Southern Nuclear Operating Company
Vogtle Electric Generating Plant Units 3 and 4
Request for License Amendment:
Vogtle 3 and 4 Proposed Emergency Action Levels (LAR-16-002)

Enclosure 6 contains the results of design reviews (based on AP1000 DCD Rev. 19) performed by Westinghouse on the EAL Technical Bases Document (Enclosure 2).

In October 2014, WEC provided editorial and technical comments to SCE&G and these comments were captured in a table entitled “Consolidated Comment Matrix from VCS, WEC, and Vogtle.” The comments were later resolved through agreements between Westinghouse, SCE&G, and SNC and the EAL Technical Bases Document was updated accordingly.

Figures

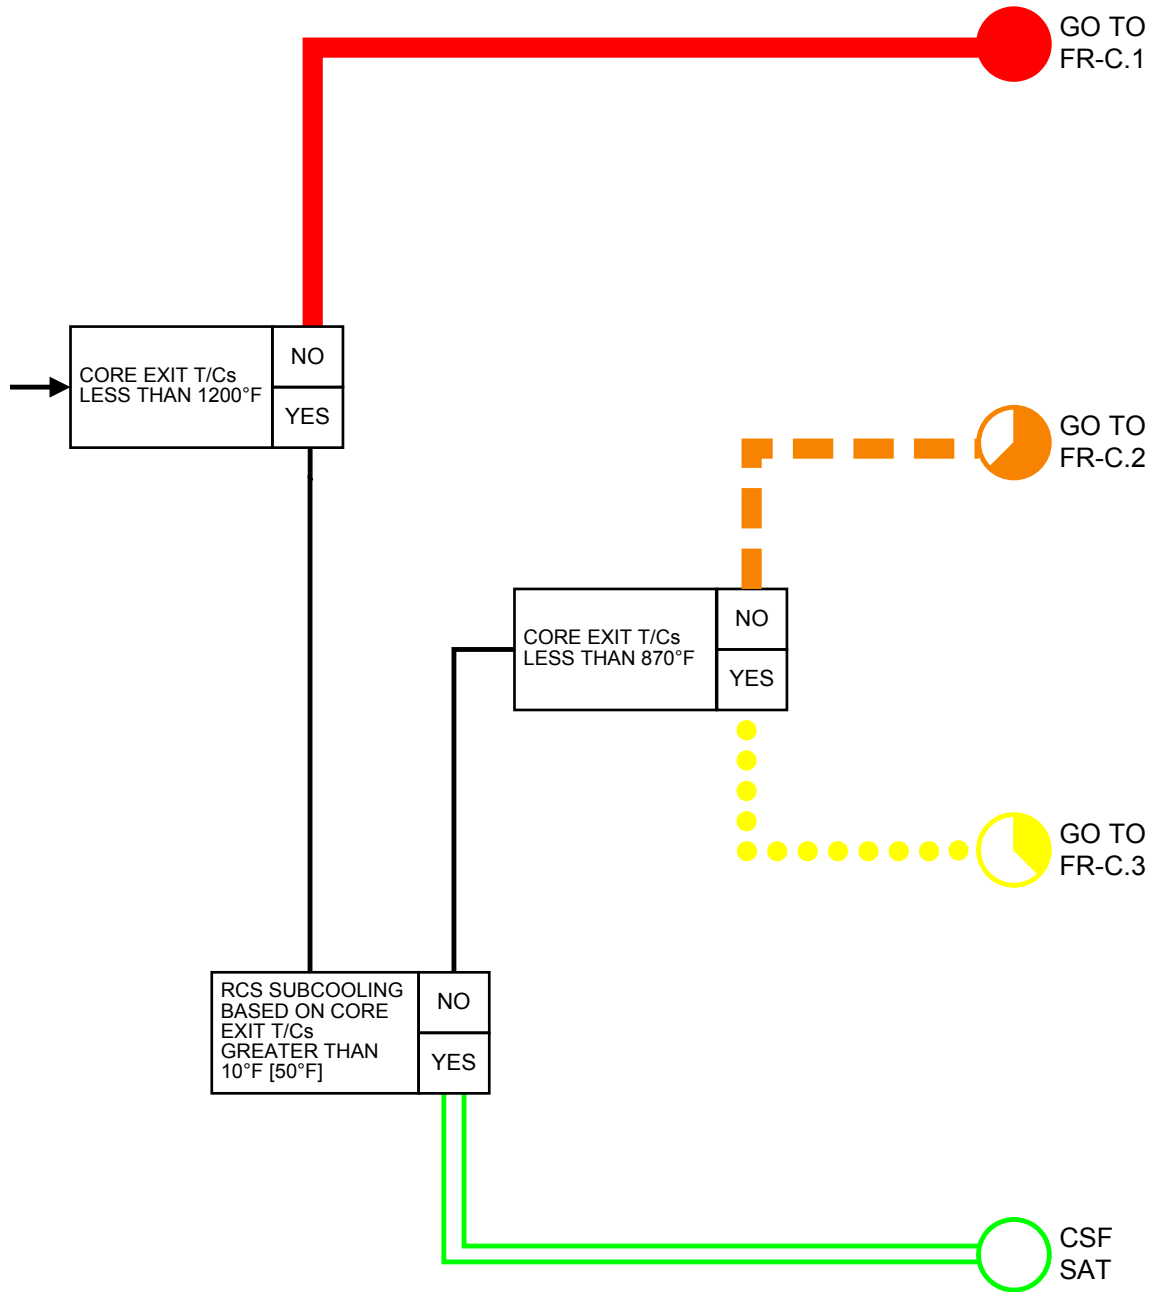
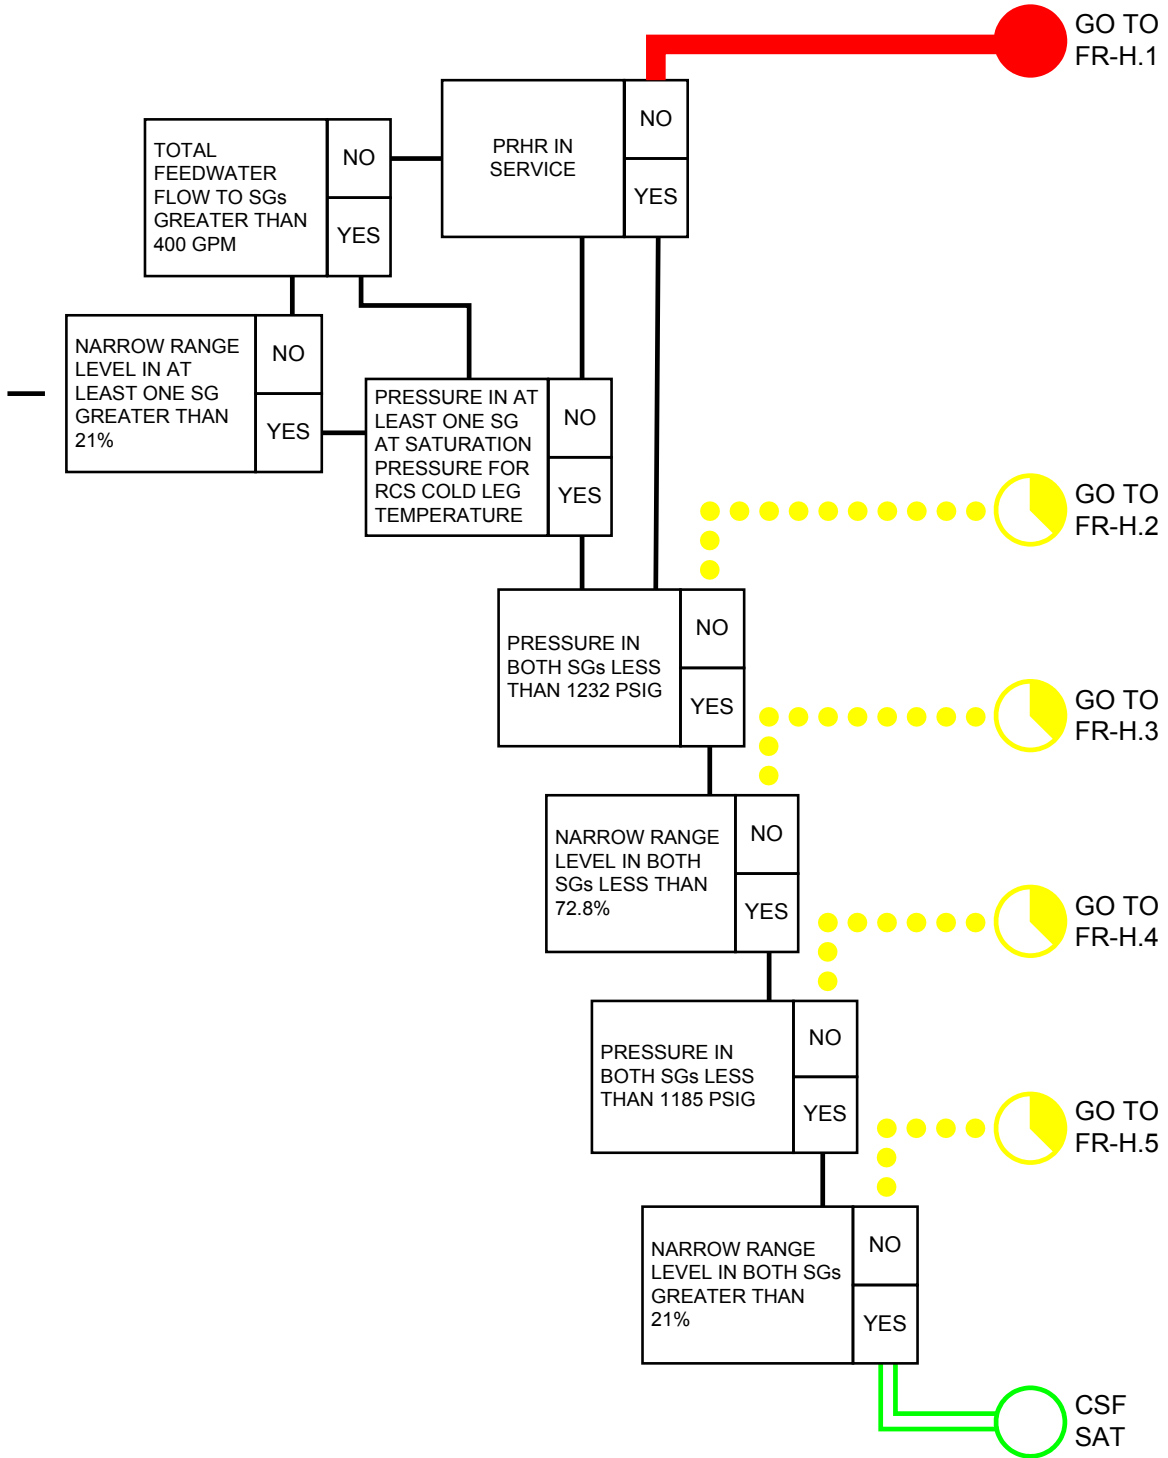
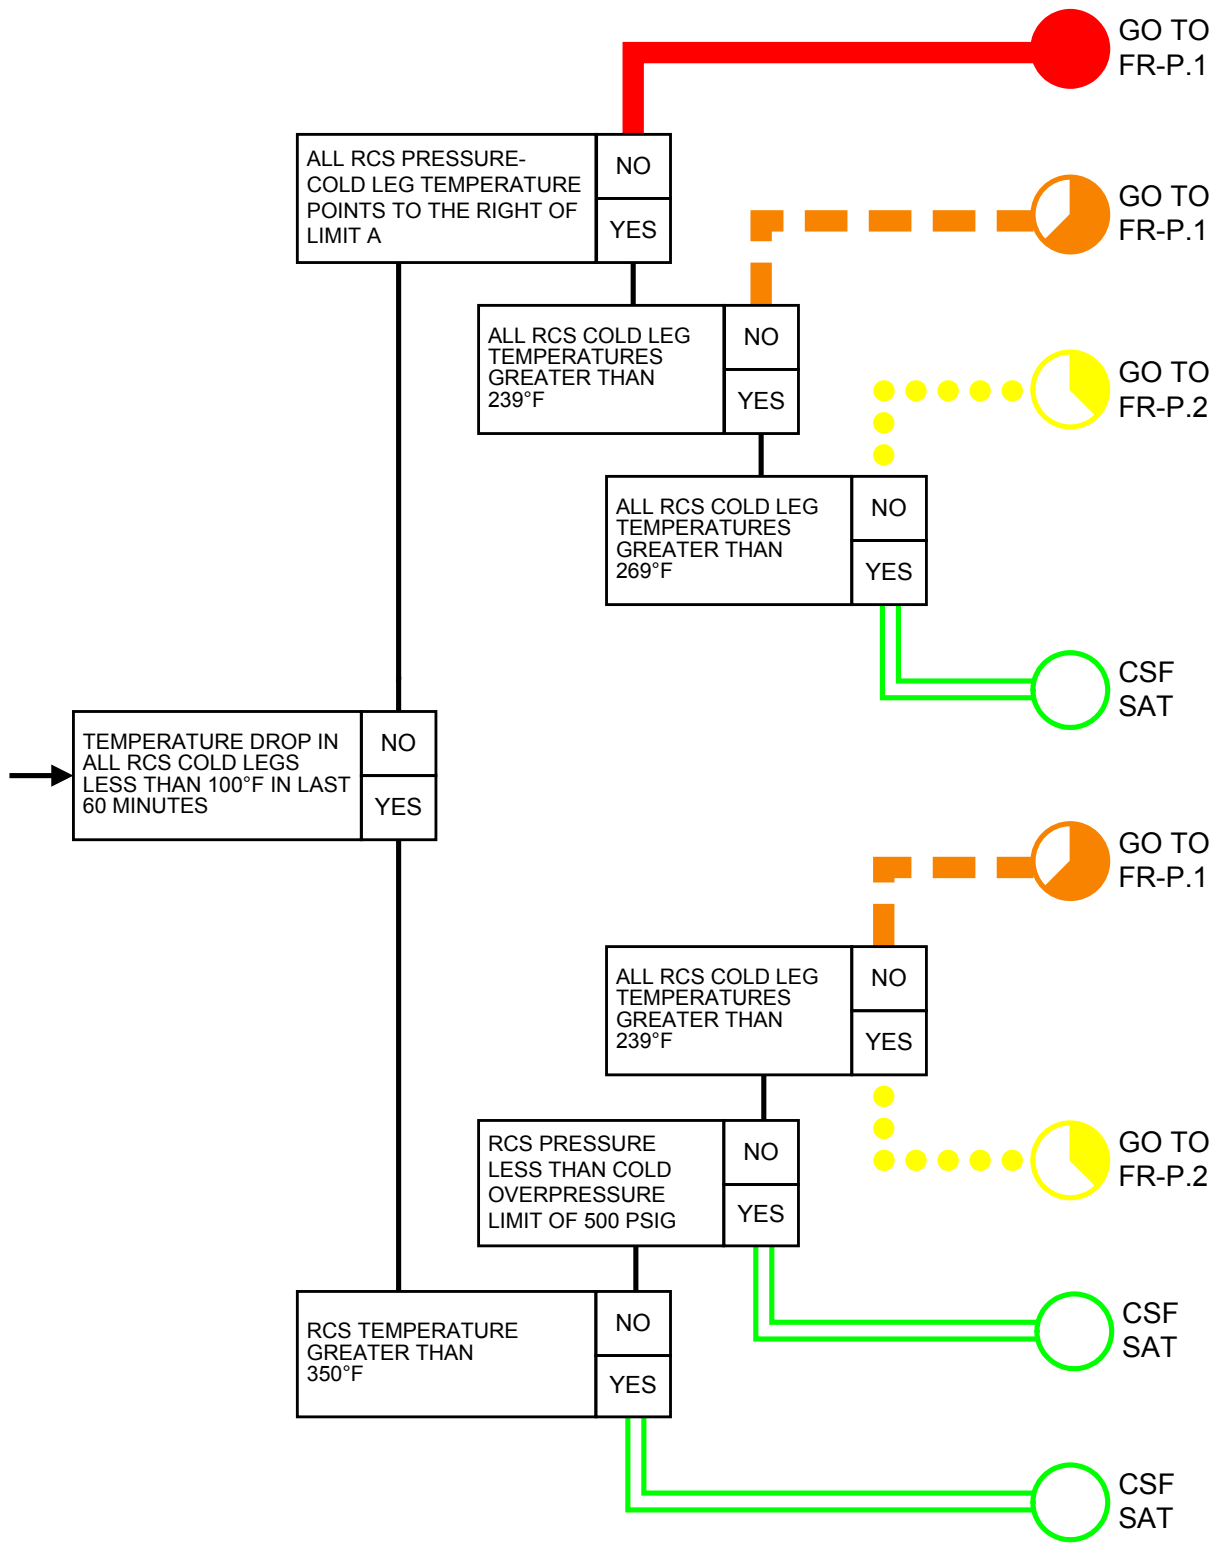
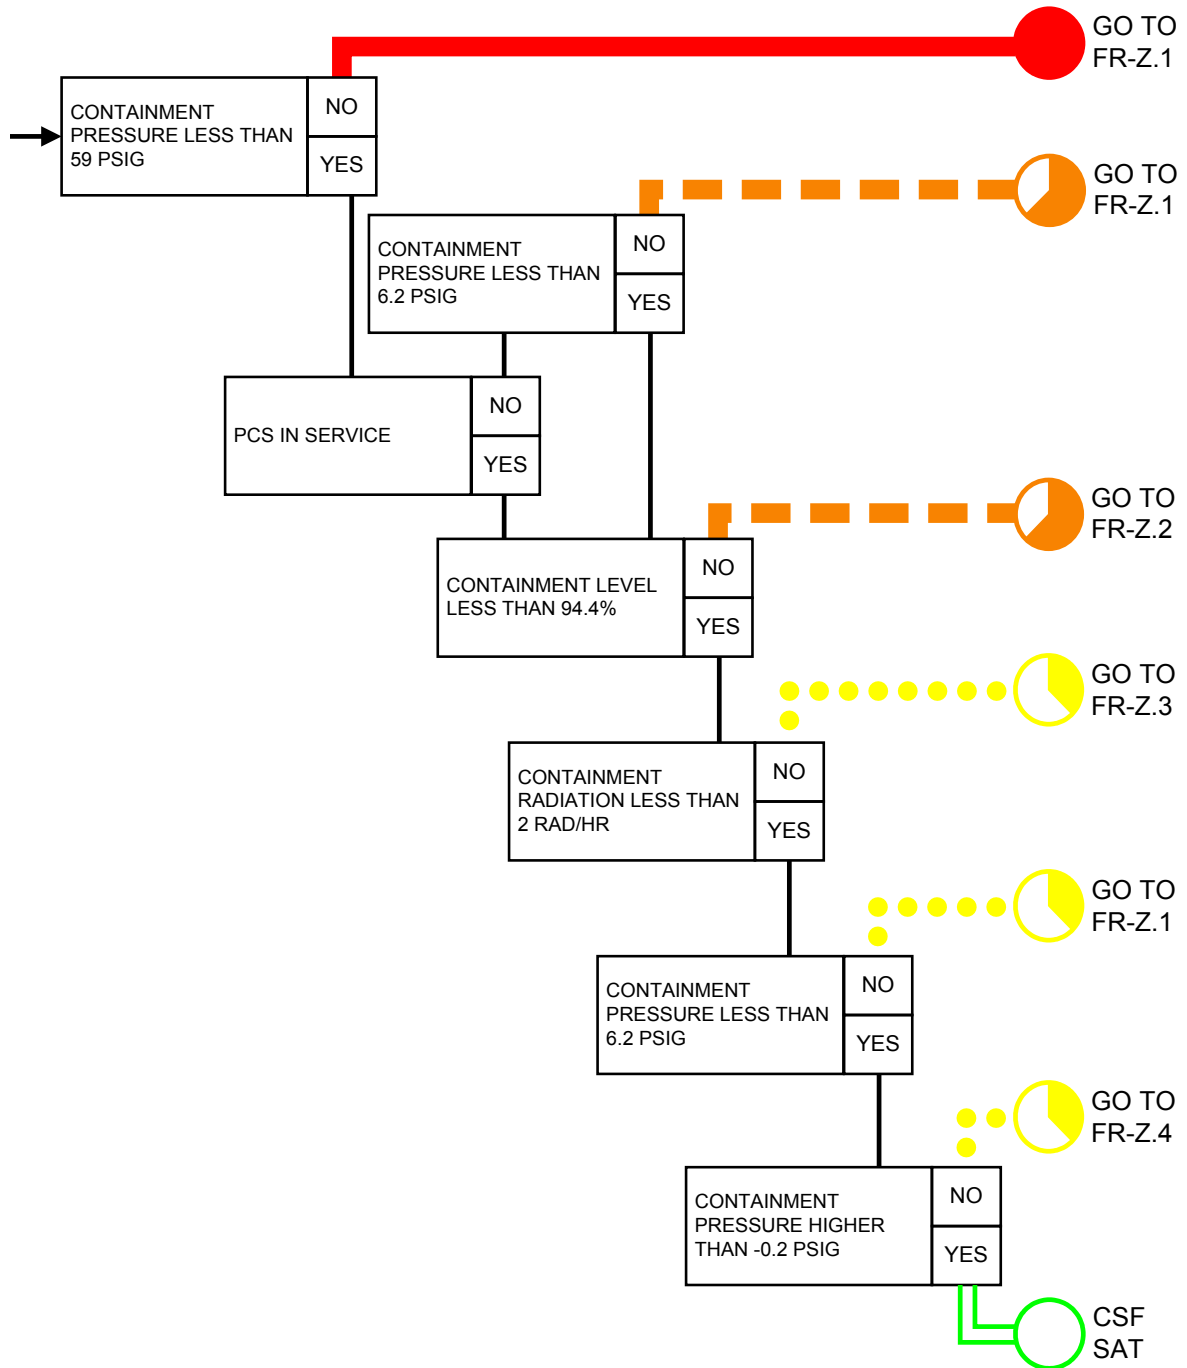
RCS Loss 1.B Basis para 1	A70. You need ADS valves to function if you are using once through cooling for PXS to operate. PRHR will function without and ADS actuation.	Remove the second sentence which says "Opening of ADS valves is required for the PXS to function".	Yes	None	Remove the second sentence which says "Opening of ADS valves is required for the PXS to function".
Att. 3 Figure 2	New Change #23 Proposed by VCS and Vogle for WEC Review: ATTACHMENT 3 Figures, Figure 2 – Use Baseline 7 information: 520 gpm should be 400 gpm, 26% [42%] should be 21% in two places	Replaced CSFST with Baseline 7 versions.	Concur with this change and its inclusion in the November 2015 EAL Technical Bases Document.	Replaced CSFST with Baseline 7 versions.	No further changes are necessary.
Att. 3 Figure 5	New Change #24 Proposed by VCS and Vogle for WEC Review: ATTACHMENT 3 Figures, Figure 5 – Use Baseline 7 information: 96.2% should be 94.4%.	Replaced CSFST with Baseline 7 versions.	Concur with this change and its inclusion in the November 2015 EAL Technical Bases Document.	Replaced CSFST with Baseline 7 versions.	No further changes are necessary.
